ONSITE SEWAGE DISPOSAL SYSTEM

**PERMIT
CONSTRUCTION**

PROPERTY ADDRESS: 12307 Pleasant View Drive

SITE PLAN FOR BAT INSTALLATION

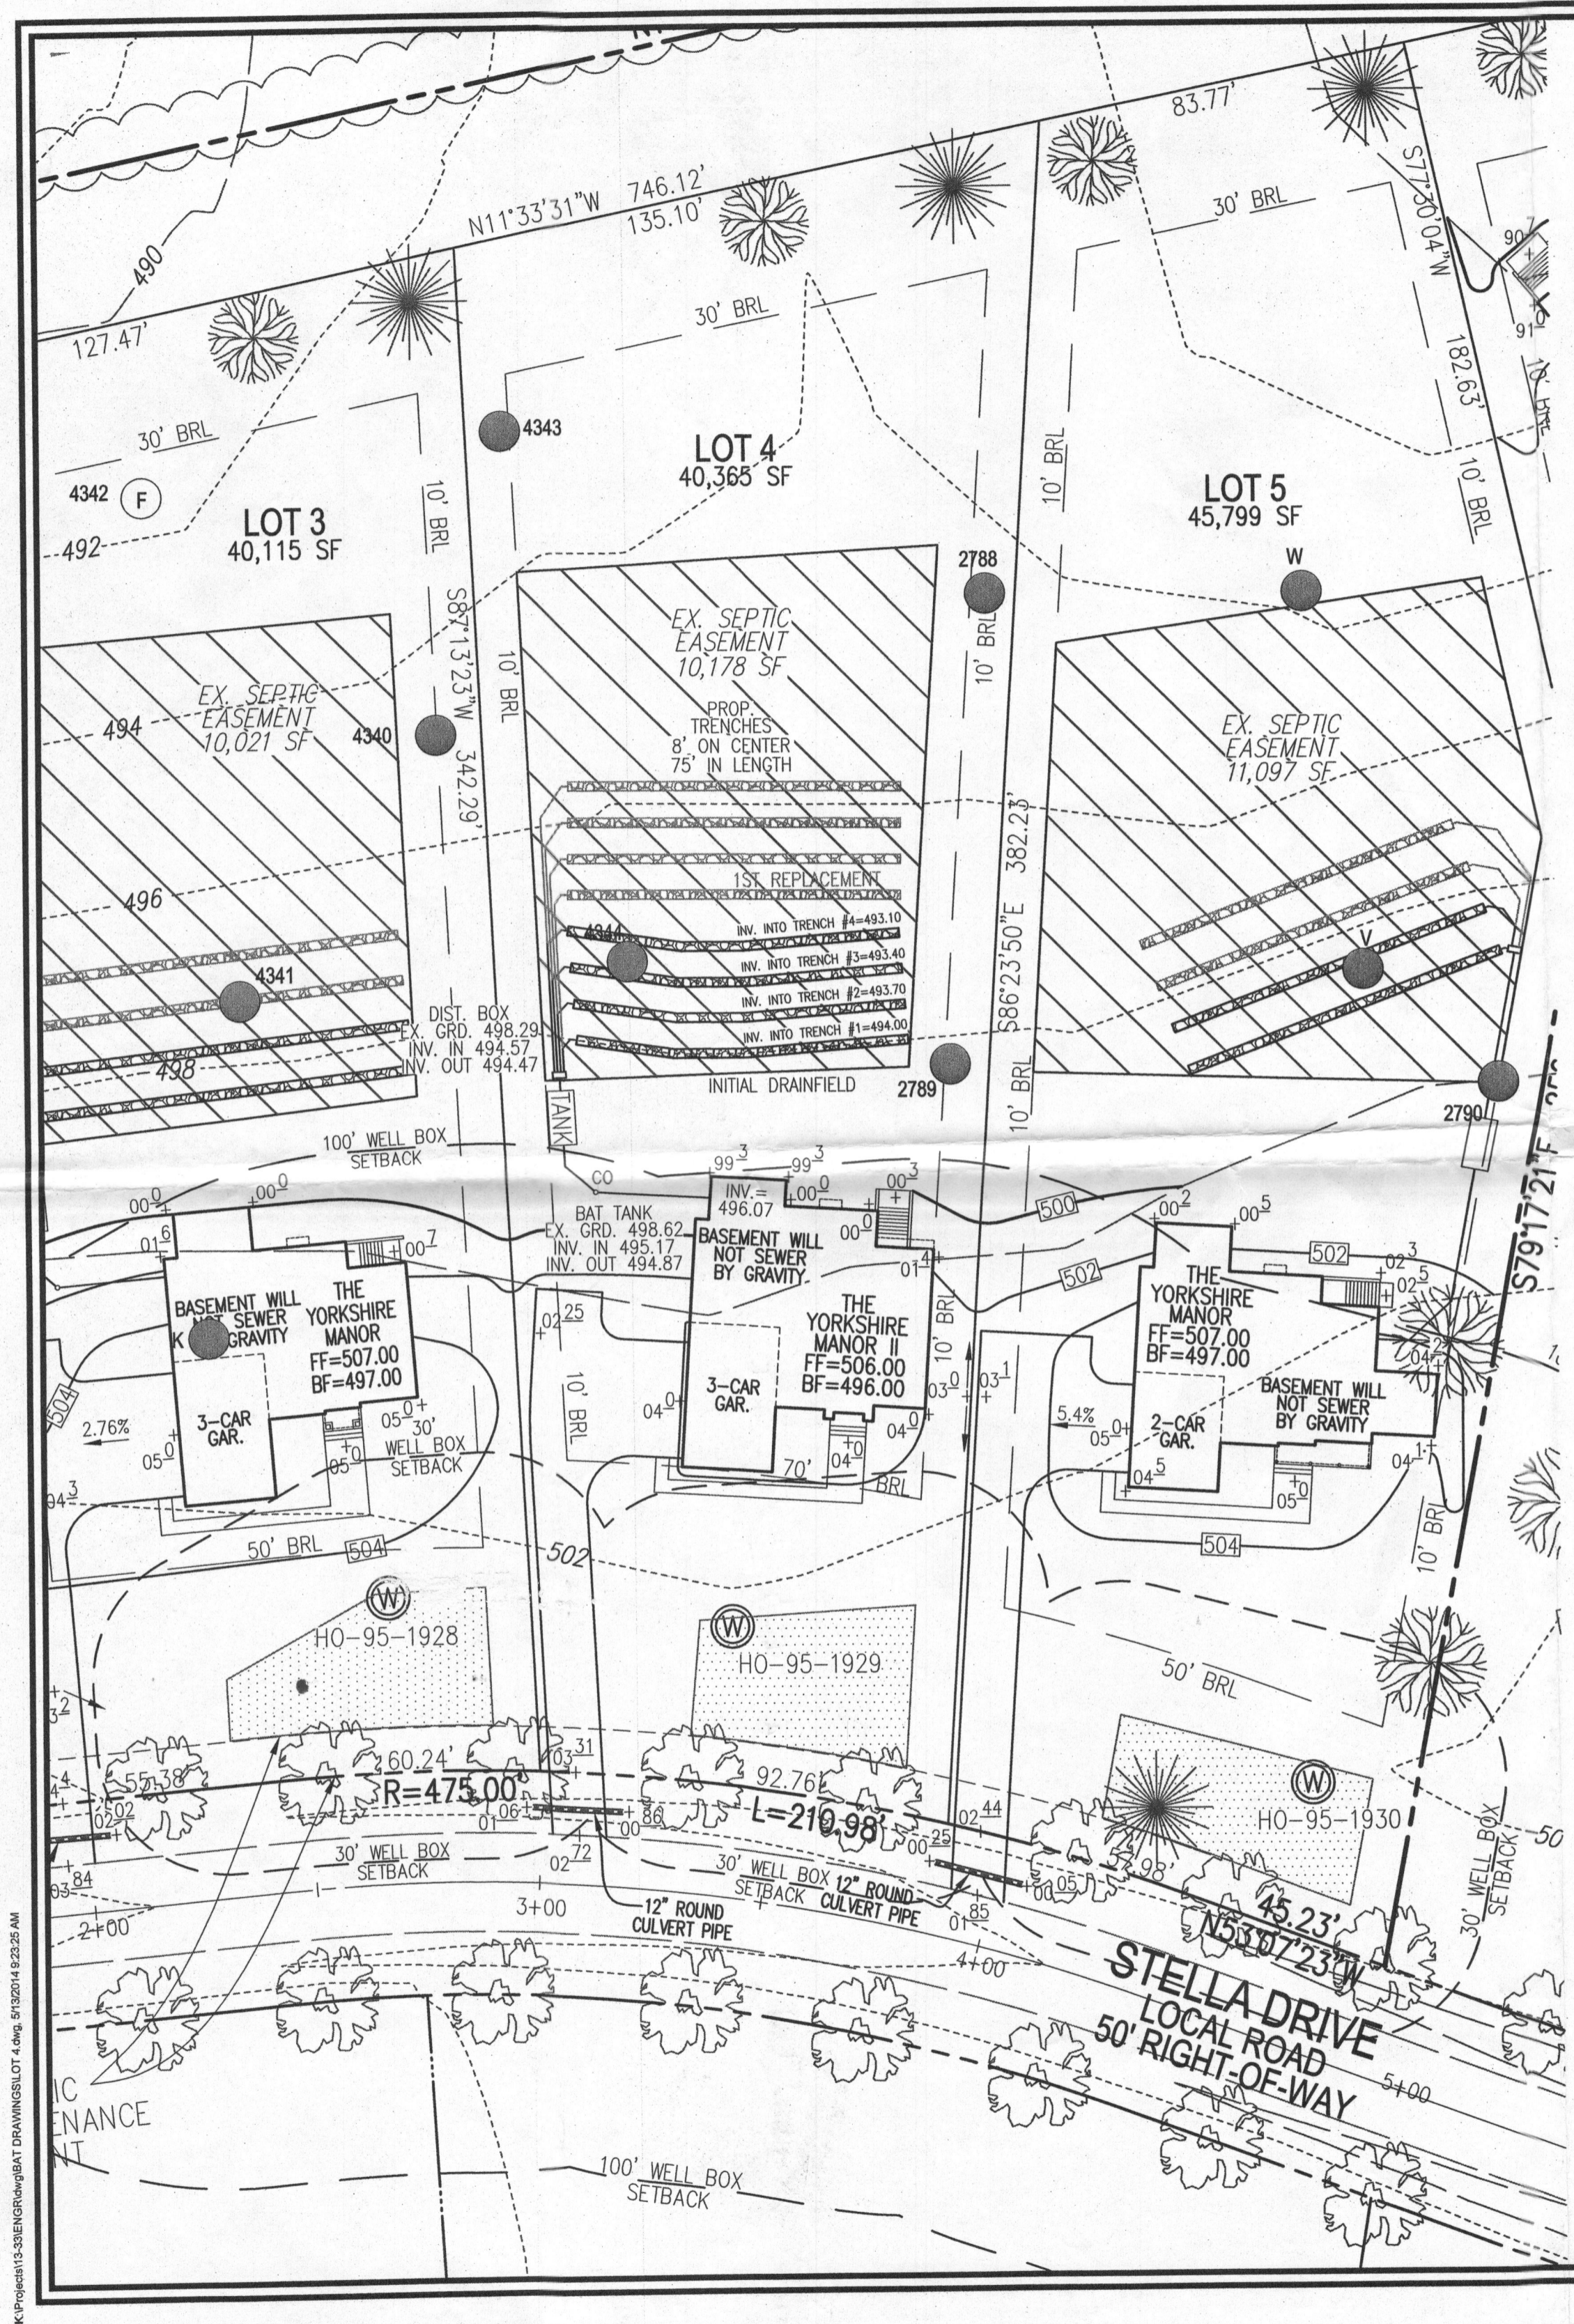
10/23/2014 Install tank per plan. Added one foot of sidewalk to trenches and shortened total trench length to 240'. Install three 80' trenches on contour across the highest usable part of the easement. No wall check in file. (BB)
